X40 Firmware Update

Machine Firmware

X40 V1.2.0

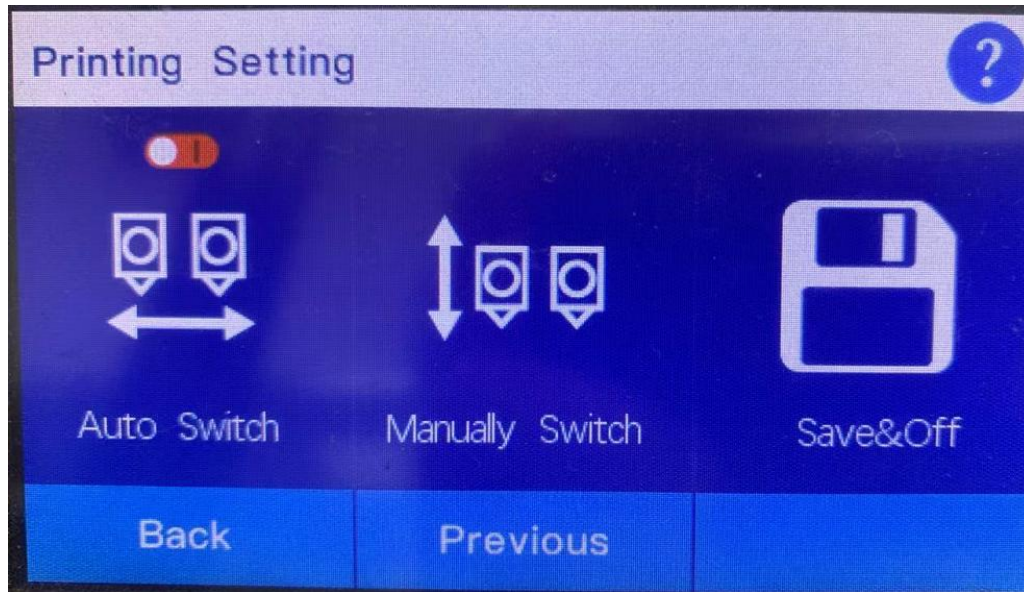
1. Add the Baby Z offset in the printing interface, you can set baby Z offset when you printing.
